Technical and Regulatory Comments

Regarding:
Draft NPDES Permit Proposed by U.S. EPA Region 10;
State of Alaska Certification under Section 401, Federal Clean Water Act;
State of Alaska Approval Under Alaska Coastal Management Plan

Concerning:
Wastewater Discharge of Tesoro Alaska Petroleum Company, Kenai, AK

June 19, 2000

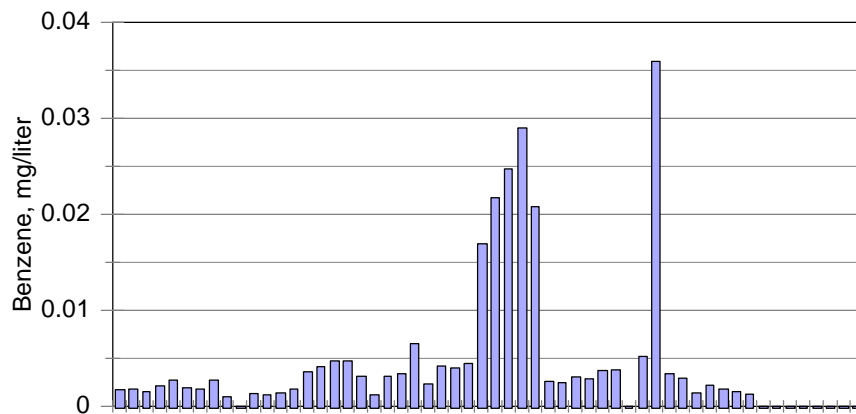
In 1997, Tesoro provided data on EPA Method 602 and 610 results on the PM Groundwater Remediation System effluent. The following chart shows this data from January, 1995 through July, 1997. Zeros in the chart are non-detects.

The chart below shows that Tesoro's PM effluent will be unable to continuously comply with the proposed benzene maximum daily permit limitation of 5.0 micrograms per liter (0.005 mg/liter) either at an internal monitoring point prior to introduction to the refinery's final secondary treatment system or as a discharge to Cook Inlet with no further treatment steps.

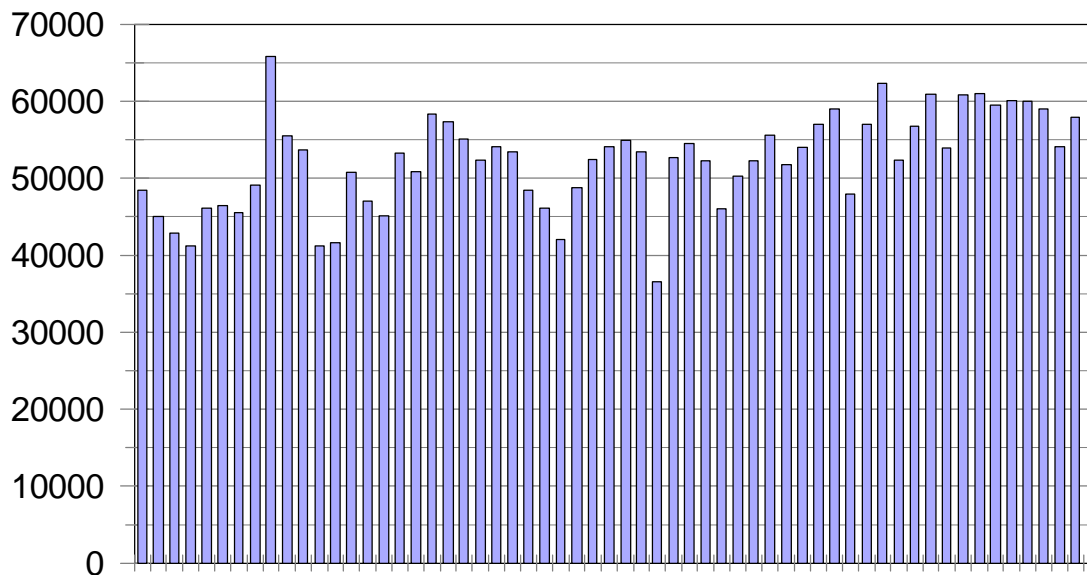
Production rate data and EPA’s analysis of it for the TAPC facility was obtained by this reviewer.²¹ The data provided included total monthly production and the number of days each month there was no production. From this, EPA staff calculated a monthly average for each month on the daily production rate. A chart of this production data for January 1990 through December, 1998 is shown below.

If EPA Region 10 continues to use its “hybrid” procedure for developing technology-based effluent limitations for this plant (a procedure to which Commentors object, as per the prior section), EPA must downwardly revise its determination of the
